PB ASSOCIATES

REVIEW OF DIRECTLINK CONVERSION APPLICATION

Final Report

The Australian Competition and Consumer Commission

Figure 3-1 - Far North Coast network

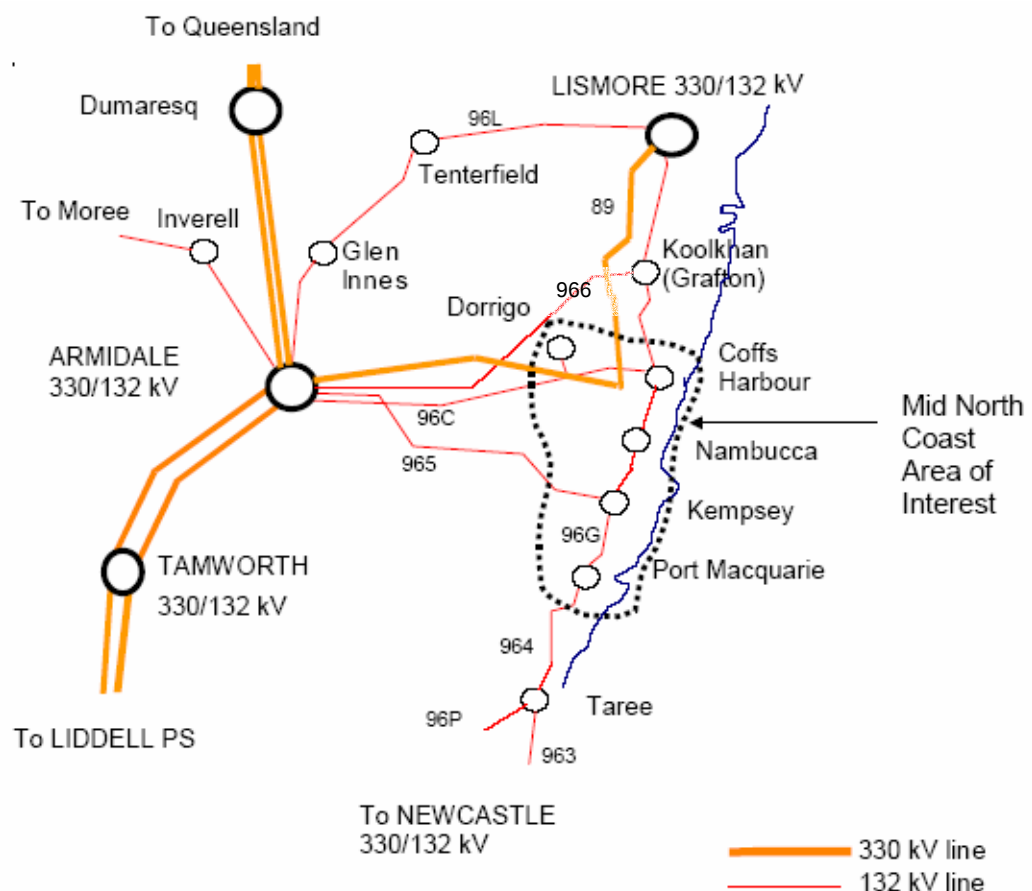
TransGrid have advised that they will be upgrading the 132kV line between Armidale and Koolkhan (Line 966) and also installing additional capacitors at their Koolkhan, Lismore and Nambucca substations. Transmission line 966 will be upgraded in a similar fashion to the recent upgrade carried out on the 132kV Armidale to Kempsey (Line 965) and due to the construction, age and topographical similarities of these two lines, similar rating increases have been assumed by PB Associates. PB Associates are of the view that these upgrades could result in a similar sustained emergency rating of approximately 120MVA under worst case conditions.

Figure 3-3 - Timeline showing the deferral of the Dumaresq to Lismore 330kV line

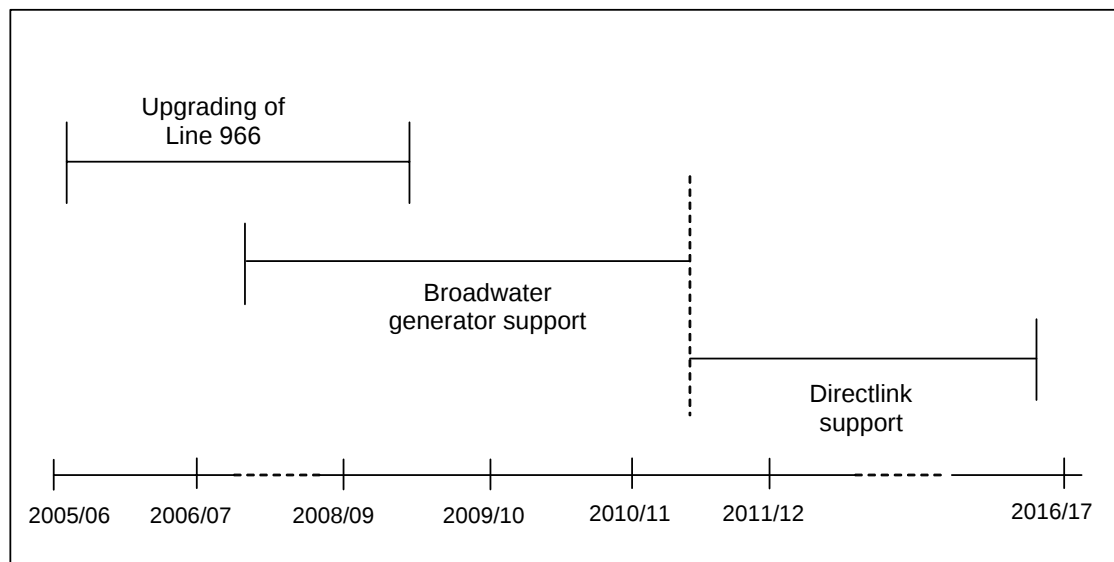
Table 4.3.1(b) indicates that voltage collapse at Koolkhan, from 2009/2010 onwards, becomes the limiting factor – rather than the thermal rating of either Line 966 or Line 977. Table 4.3.1(b) also indicates the amount of network support required to negate this constraint. At 2011/12 Table 4.3.1(b) of the BRW report indicates that 28MW is required to maintain acceptable voltage levels at the Koolkhan substation. The 30MW generator at the Broadwater sugar mill is scheduled to be commissioned by this date and is capable of exporting at least 26.7MW. Allowing a 0.95 availability factor for this generator and the fact that it will be incentivised to operate over peak periods. PB Associates has concluded that this generator ought to be able to defer the need to construct the 330kV Dumaresq to Lismore line from 2008/09 till after 2010/11.

The timeline associated with the need for the new Dumaresq to Lismore 330kV line is shown in Figure 3-3.

Figure 3-4 - Alternative 0 schematic diagram

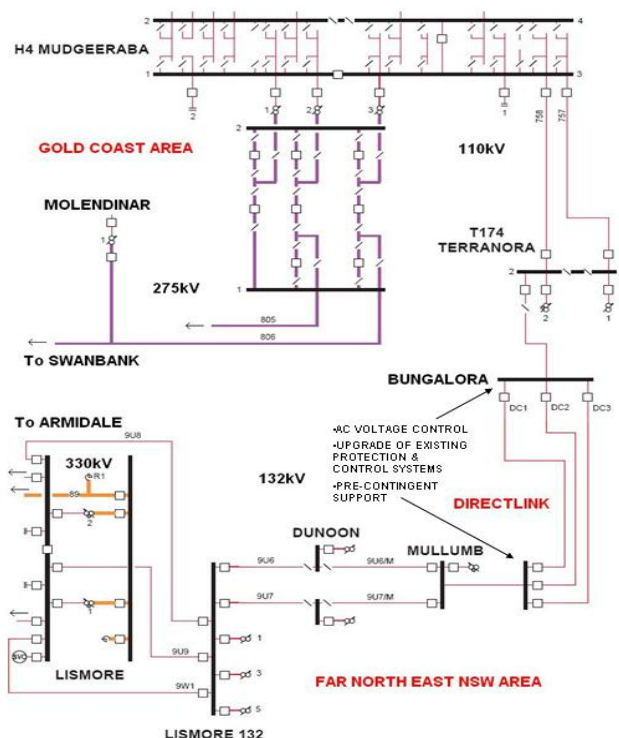
Alternative 0 is shown schematically in Figure 1. The DJV submission and the BRW report does not provide details of the protection and control system upgrades required.

substantial reactive power requirements are manually adjusted by the operator on the other two converters. There is a concern, however, in so far as the level of AC voltage control for two thirds of the reactive power capability of the facility is not, at this stage, equivalent to an SVC as stated in the BRW report³¹. PB Associates has not been advised when the Bungalora converters will be in a position to provide the full level of AC voltage control. PB Associates understands that the improvement of the AC voltage control, to the degree that it is equivalent to an SVC, is included in the upgrade works proposed by the DJV.

Figure 3-6 - Alternative 2 schematic diagram

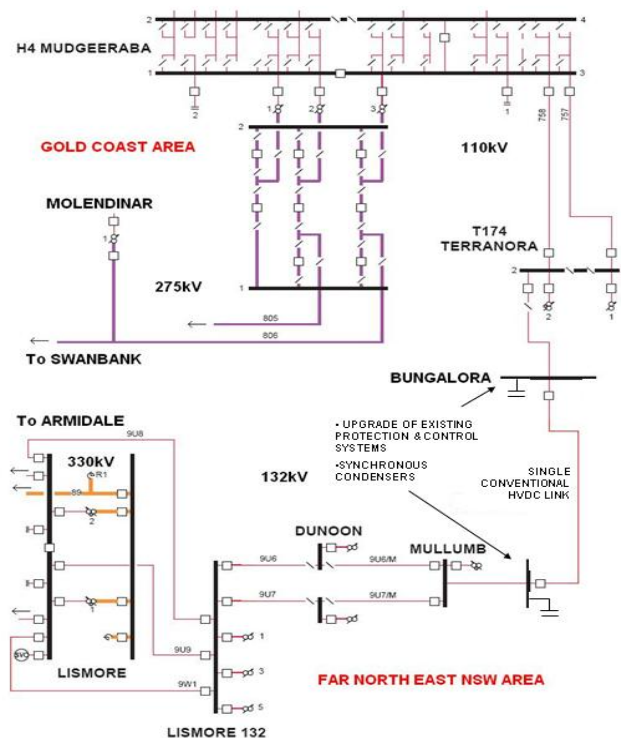
Alternative 2 is shown schematically in Figure 3-6. The DJV submission and the BRW report do not provide details as to the exact protection and control system upgrades required.

For Alternative 2, the DJV has proposed the installation of additional reactive plant to provide reactive power support independent of the active power flows through the converter⁶⁰. The synchronous condensers proposed by the DJV may provide additional reactive capability to support the Gold Coast and northern NSW coastal regions if required, though no details have been provided on the level of support available. Any reactive power support provided by this installation will most likely be in discrete steps rather than “SVC like” as in Alternatives 0 and 1.
